**PINEHURST DELANY'S ADDITION TO SPRINGHILL  
SUBDIVISION, BLOCK 72, RESUBDIVISION OF LOTS  
1, 2, 3, & 4**

APPLICATION NUMBER 14 DATE October 4, 2007

## DETAIL SITE PLAN

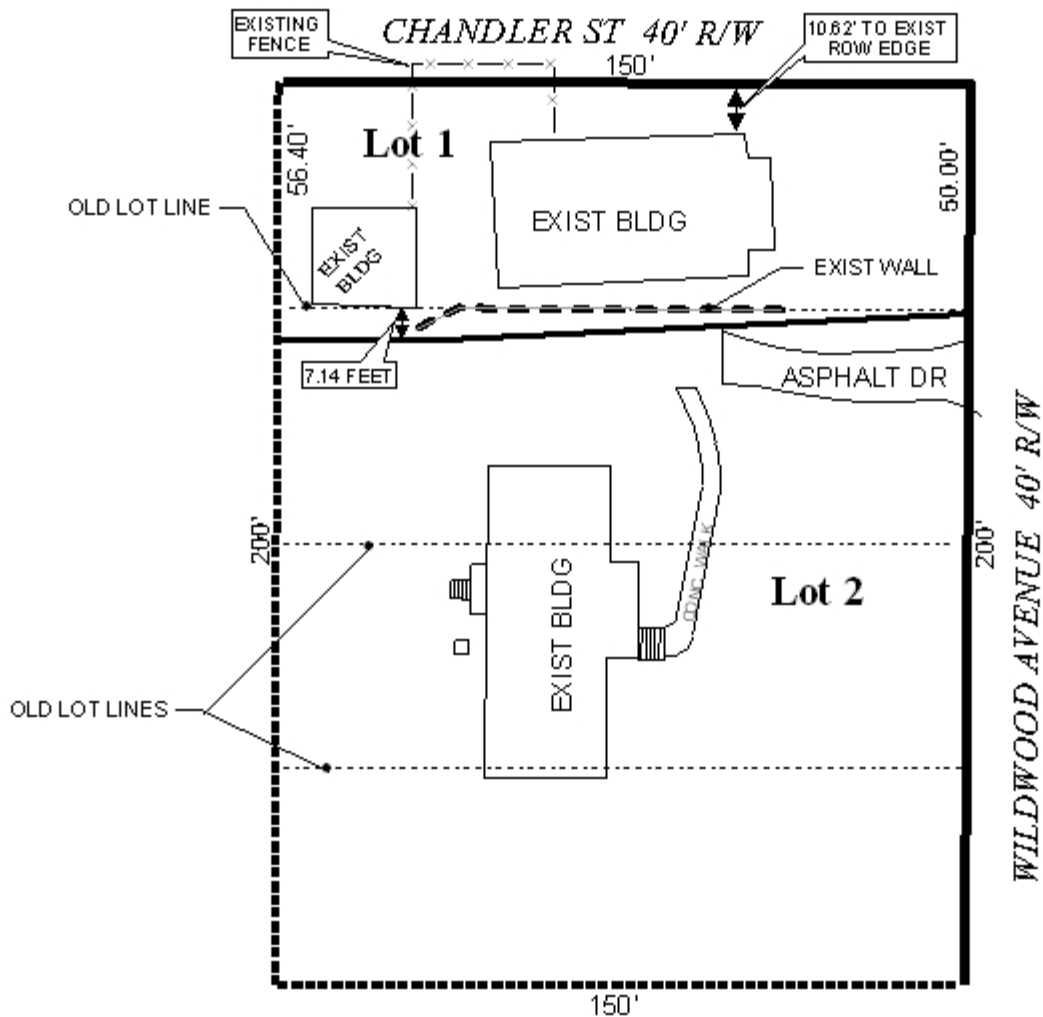
This subdivision application, as proposed, will adjust the South property line of the existing Lot 1 to create a new Lot 1, resulting in all structures on Lot 1 being at least 7.14 feet from the South property line. It appears that there is adequate room on Lot 2 to adjust the property line to allow an 8-foot side yard setback for the garage for Lot 1, thus precluding any future setback issues.

The site fronts onto Wildwood Avenue, a minor street with a right-of-way of 40 feet, and Chandler Street, a minor street with a right-of-way of 40 feet. Right-of-way should be dedicated to provide a minimum of 25-feet, as measured from the centerline of each street. The minimum building setback line should be adjusted to accommodate the right-of-way dedication: a 25-foot minimum building setback should be depicted along Wildwood Avenue, and the Subdivision Regulation minimum building setback requirements should be waived along Chandler Street in favor of the 9.5 feet that would be required by Section 64-4.D.3. of the Zoning Ordinance for a 50-foot wide lot where the Chandler Street side is considered a side yard, and where the residence to the rear of the lot faces the opposite direction.

The property line at the corner should be revised to have a radius, in conformance with Section V.D.6. of the Subdivision Regulations.

Proposed Lot 1 should be limited to the single existing curb-cut onto Chandler Street, and Lot 2 should be limited to one curb-cut onto Wildwood Avenue.

Finally, the plat depicts a fence that apparently has been constructed since the new house was built. It appears that the fence was constructed without a permit and that it encroaches into the public right-of-way. The fence must be removed from the public right-of-way, and a permit must be obtained to allow the fence per the standard requirements: the fence may not exceed 3 feet in height within the required side yard setback.

- 1) revision of the plat to dedicate sufficient right-of-way to provide 25-feet, as measured from the centerline, along both streets;
- 2) revision of the property line at the corner to have a radius, in conformance with Section V.D.6. of the Subdivision Regulations
- 3) depiction of the minimum building setback line to accommodate dedication, so that the minimum building setback line is 25 feet from the new right-of-way edge of Wildwood Avenue, and 9.5 feet from the new right-of-way edge of Chandler Street;

- 4) placement of a note on the final plat stating that Lot 1 is limited to its existing curb-cut onto Chandler Street and that Lot 2 is limited to one curb-cut onto Wildwood Avenue, with the size, design and location of all curb-cuts to be approved by Traffic Engineering;
- 5) revision of the property line between Lots 1 and 2 so that a minimum of an 8 foot setback is provided adjacent to the garage;
- 6) revision of the lot sizes in square feet to accommodate the changes to the plat;
- 7) the obtaining of a building permit for the existing fence prior to the signing of the final plat, and the modification of the fence so that it is not within the public right-of-way, and that it does not exceed the height limitations within the setback area along Chandler Street; and
- 8) full compliance with all other municipal codes and ordinances.
